Historic Preservation Commission

Staff Report

Case #: HPC-28-26

Proposed Work: Petition for a Certificate of Appropriateness for the replacement of windows on the primary structure on the property located at 1020 & 1022 17th Avenue in the Druid City Historic District (Council District 4).

Melrose Windows

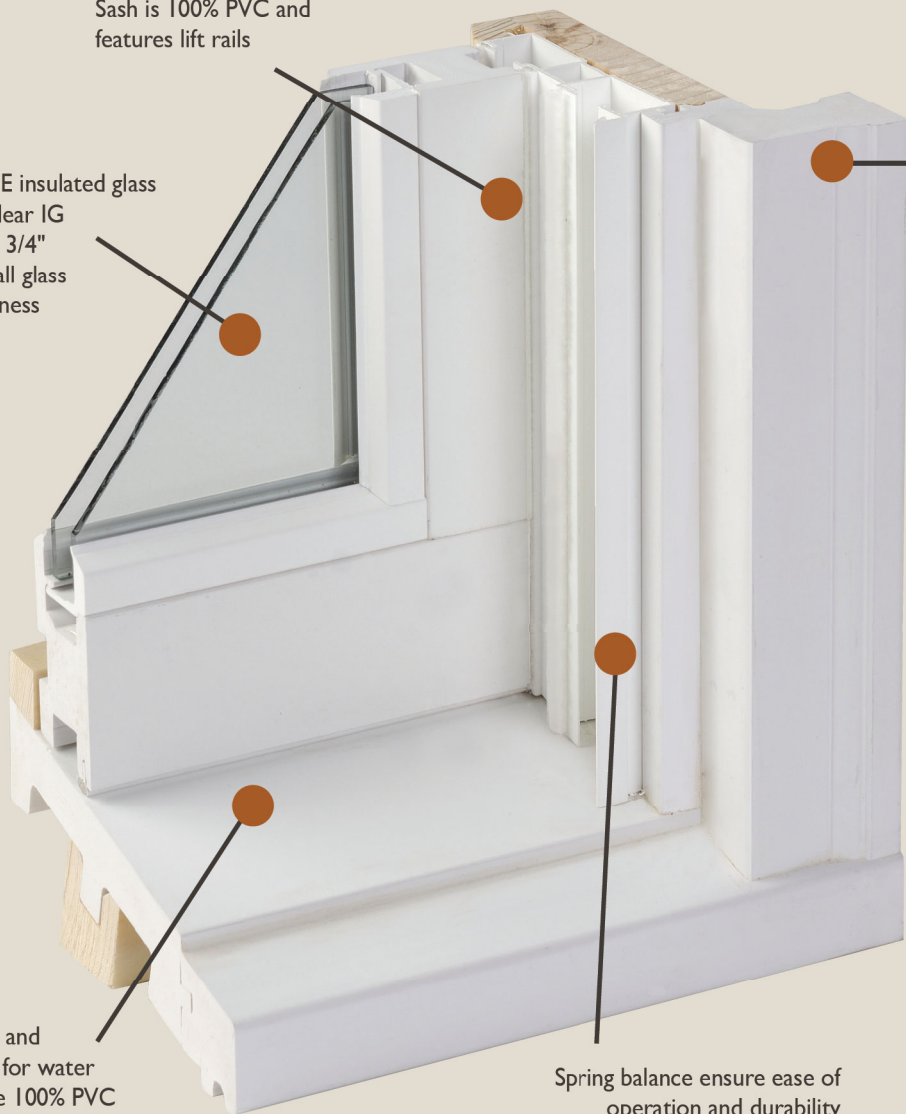
Cellular PVC is an appropriate material for windows per the Design Guidelines.
